Access Compliance Report

Public Rights-of-Way

(Curb Ramps)

Intersection ID: 10022610	Main Street: CARMEL_RD	Cross Street: N/A	Location: SW
ADA ID: 69C269C3ACCD	Ramp Type: PerpDiag	Initial Pass/Fail: Fail	Overall Compliance: No
Severity Score: 12.5			
Codes/Mitigation Info/Possible Solution		Field Measurements/Component Compliance

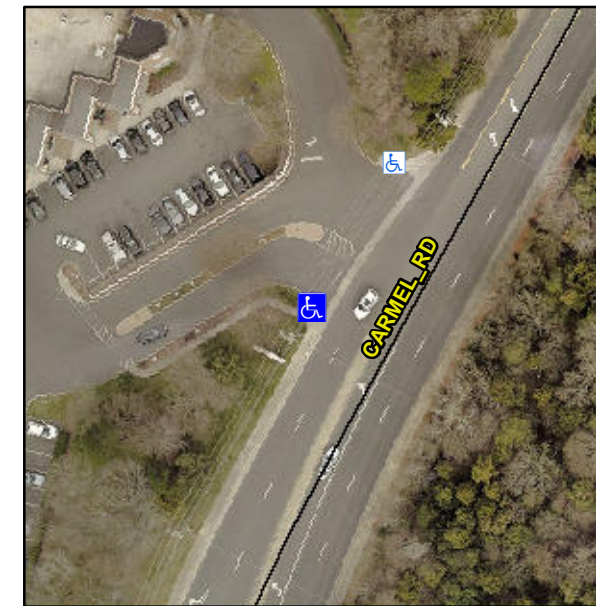
R304.5.3

Compliance	Description	Data	Compliance	Description	Data
N/A	Ramp Length (in)	60.0	Yes	Ramp Slope (%)	5.8
Yes	Ramp Width (in)	48.0	No	Ramp XSlope (%)	6.9
N/A	Flare Type LT	N/A	N/A	Flare Type RT	N/A
N/A	Flare Slope LT (%)	N/A	N/A	Flare Slope RT (%)	N/A
N/A	Flare Traversable LT?	N/A	N/A	Flare Traversable RT?	N/A
N/A	Landing Length (in)	N/A	N/A	DWS Provided?	N/A
N/A	Landing Width (in)	N/A	N/A	DWS Contrast?	N/A
N/A	Landing Slope (%)	N/A	N/A	DWS Length (in)	N/A
N/A	Landing X Slope (%)	N/A	N/A	DWS Full Width?	N/A
N/A	Landing Curb? (Y/N)	N/A	N/A	DWS Offset (in)	N/A
N/A	Shared Landing?	N/A			
N/A	Gutter Ponding?	N/A	N/A	Gutter Slope (%)	N/A
N/A	Gutter Lip Ht (in)	N/A	N/A	Gutter X Slope (%)	N/A
N/A	Painted X Walk1?	No	N/A	Painted X Walk2?	No
	X Walk 1 Direction	To E		X Walk 2 Direction	To NE
N/A	X Walk 1 Width (in)	N/A	N/A	X Walk 2 Width (in)	N/A
	X Walk 1 Slope (%)	4.7		X Walk 2 Slope (%)	1.1
	X Walk 1 X Slope (%)	4.0		X Walk 2 X Slope (%)	5.9

Remove & Replace Curb Ramp With Two New Directional Ramps or Equivalent.
